1 – ENGINE

505 V6: Modification to the fan coupling

From serial number : 1.999.220

Identification

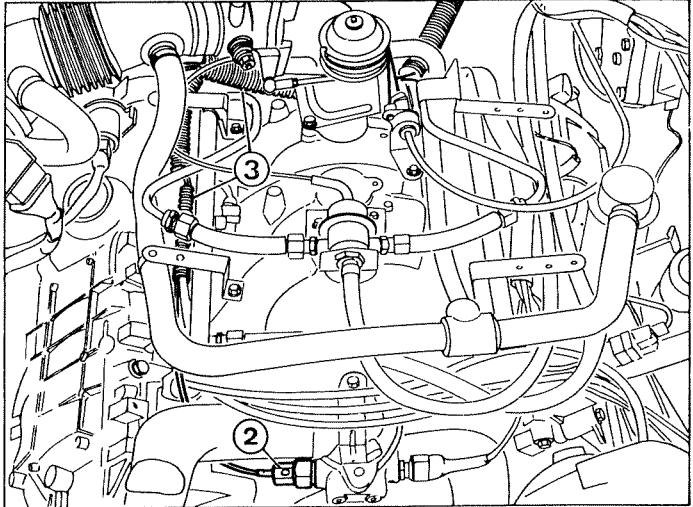
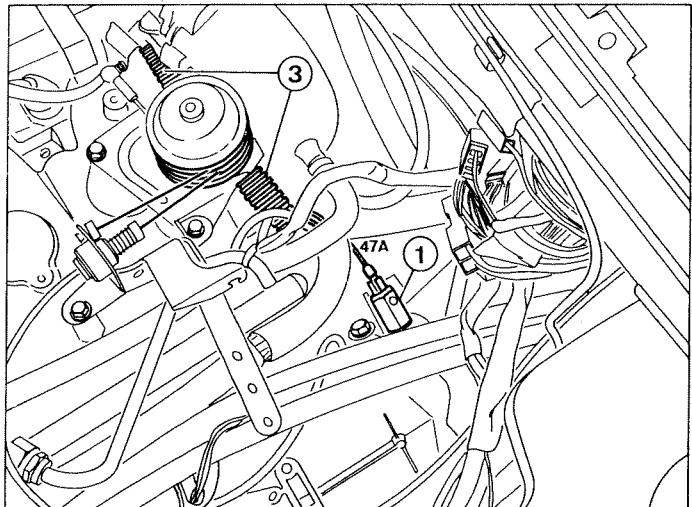
The coupling rated at 75°C is replaced by a coupling rated at 80°C.

| Earlier assembly | Later assembly |
| Not supplied by Parts | Part Number 1259.20 |

- Parts will supply only the coupling rated at 80°C Part Number 1259.20.
- Replacing a coupling rated at 75°C by one rated at 80°C requires the following modifications:

- Disconnect wire 47A from the thermistor (1) and lengthen it with 0,6 mm² wire to connect it to the thermal switch (2) before passing through the convoluted sleeve (3).
- Fit an expansion bottle cap rated at 1 bar (coloured orange) Part Number 1303.42.

- Replace the thermal switch (4) in the radiator by a thermal switch Part Number 1264.18 (93° – 88°, 97° – 92° coloured white).
